ADDENDUM No. 2

ITB No. 4496

West Liberty Reconstruction

PROJECT MANAGEMENT - PUBLIC SERVICES - CITY OF ANN ARBOR
WEST LIBERTY STREET RECONSTRUCTION
S. FIRST ST. - N. MAIN ST.
STORMWATER TREE TRENCH DETAIL

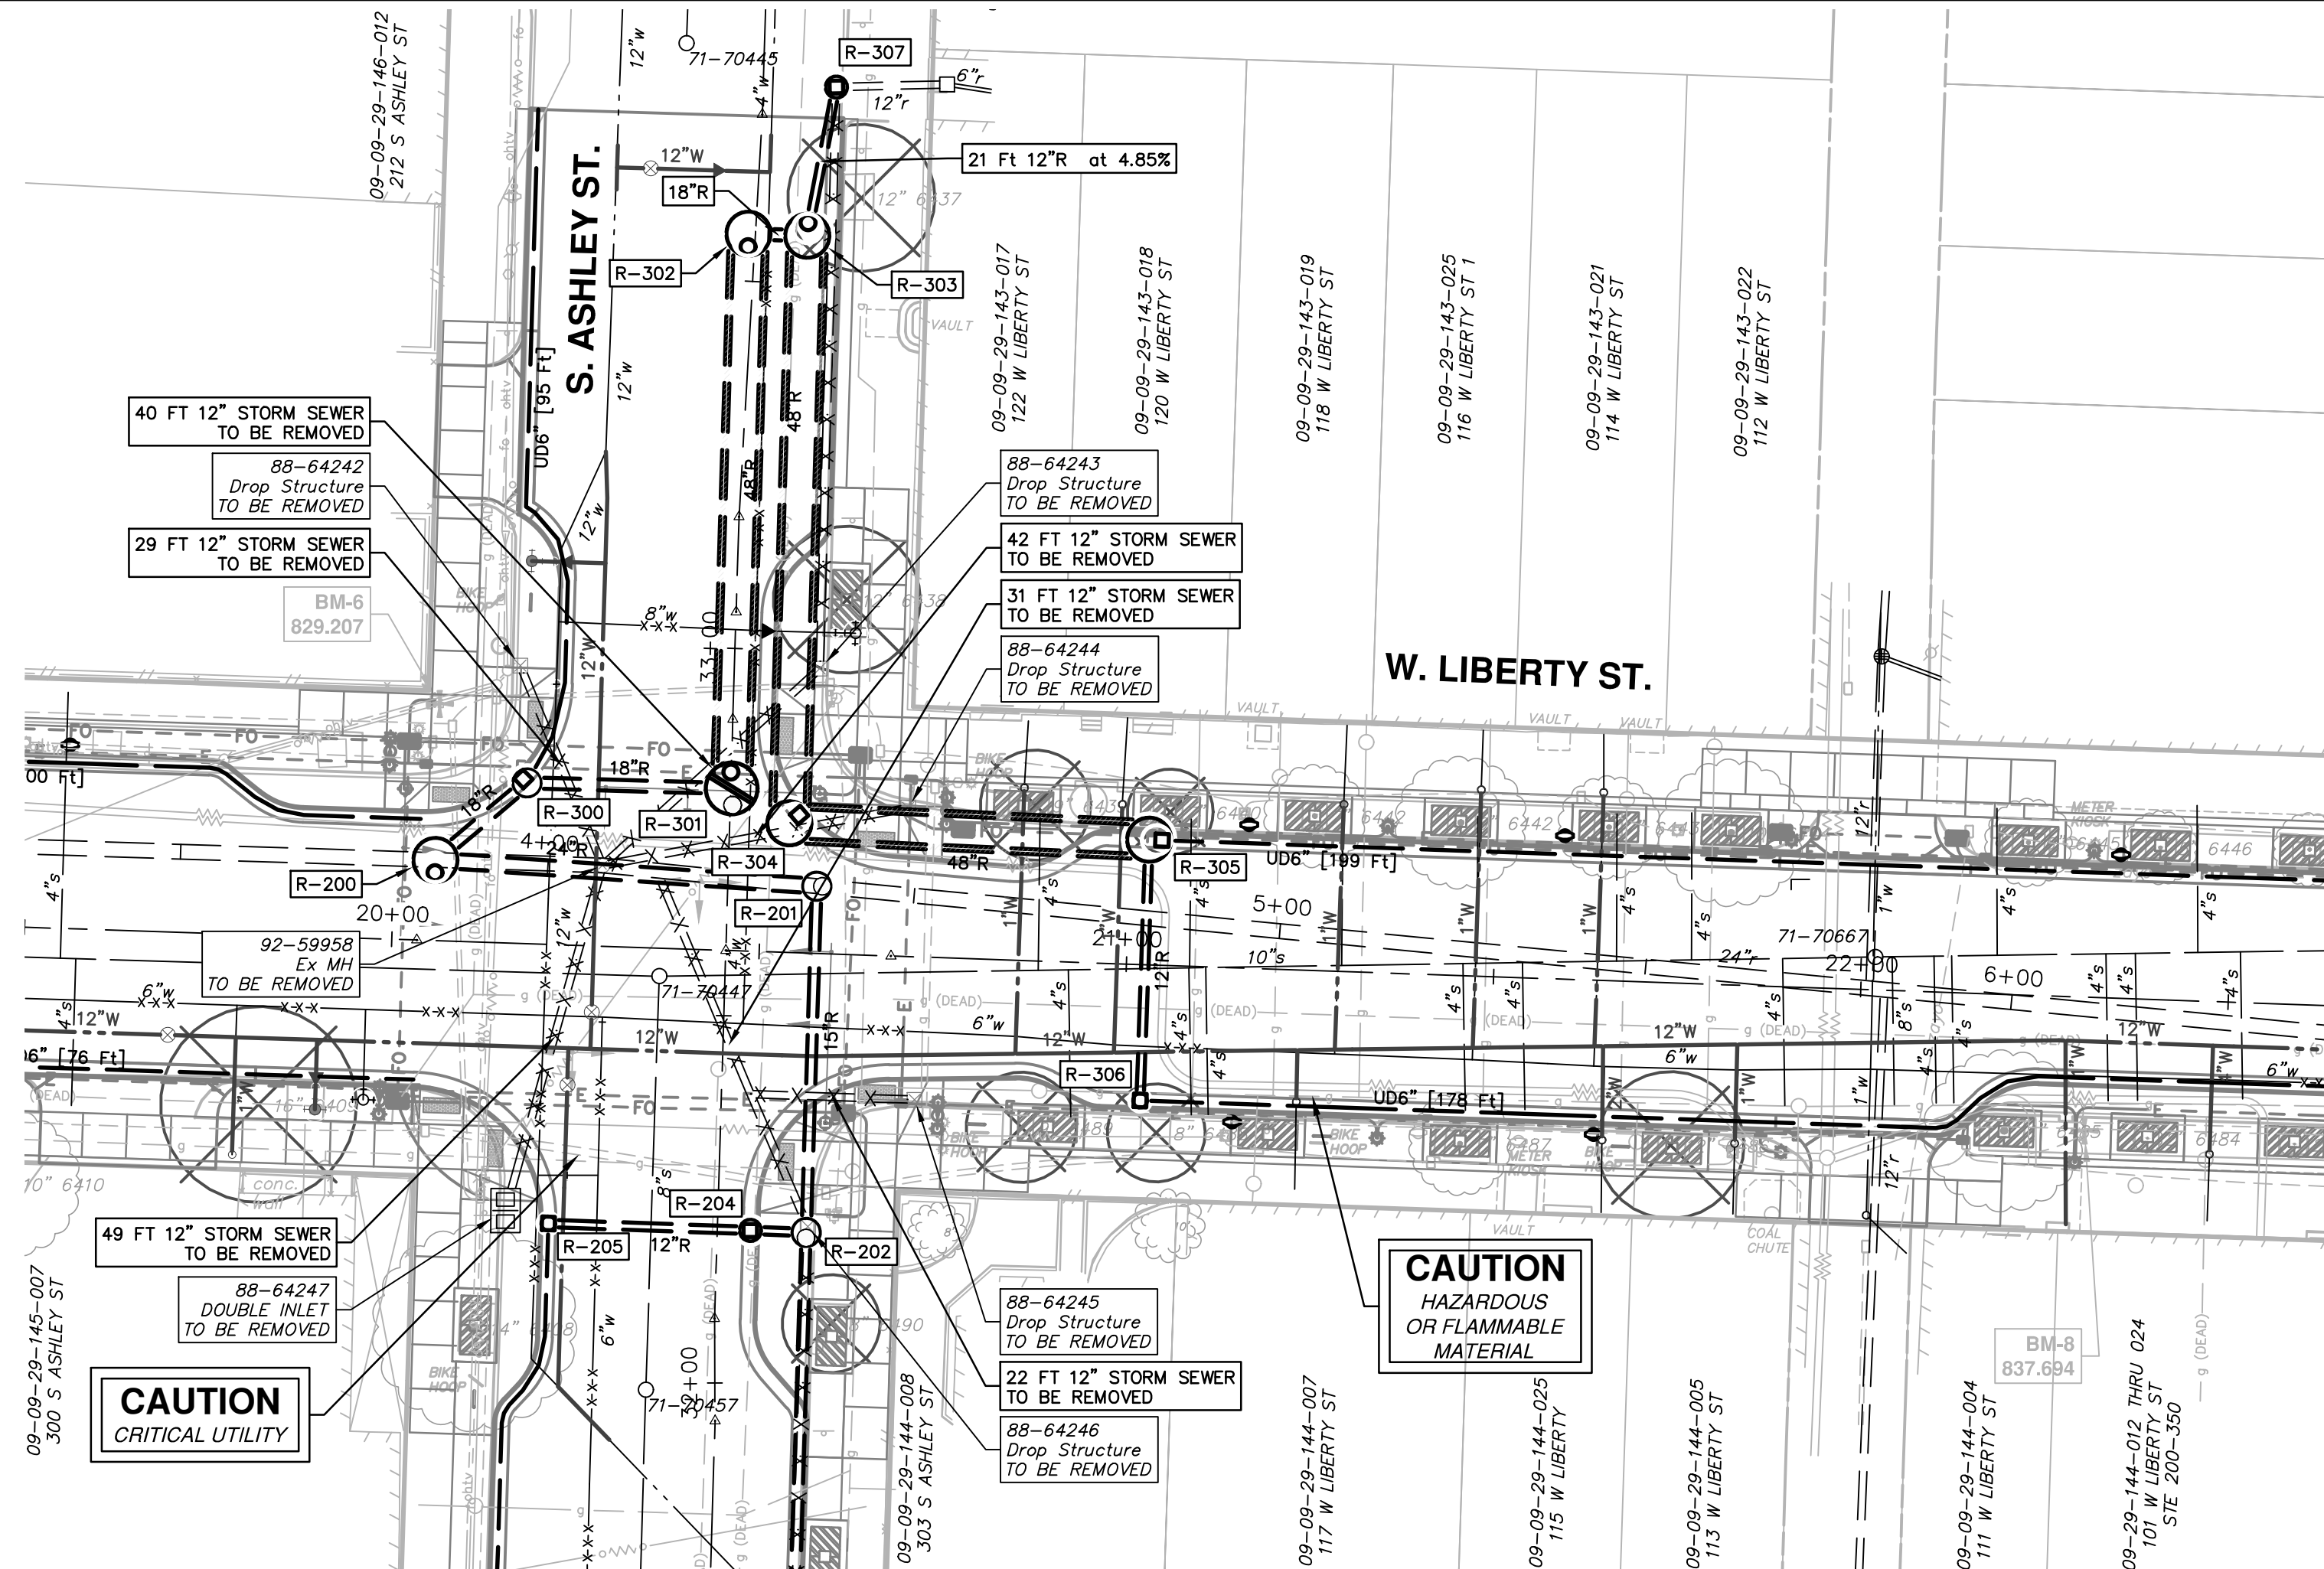
- Pg 8 – Infiltration Trench detail revised.
- Pg 37 – Trench backfill detail revised to IA.
- Pg 40 – Temporary water main interconnect between phases has been added.

2. Will the Pay Item 4047001 "Infiltration Trench" include payment for volumes of excavated material / backfill as necessary to install OSHA approve excavations? For example, the detail as shown on sheet 8 of the plans is not realistic. Based on the soil borings and insitu soils there is no possibility of vertical trench walls for this application. This may also increase the sidewalk removal and replacement limits.
 - Response: The trench wall detail has been revised. Update plan sheet included.
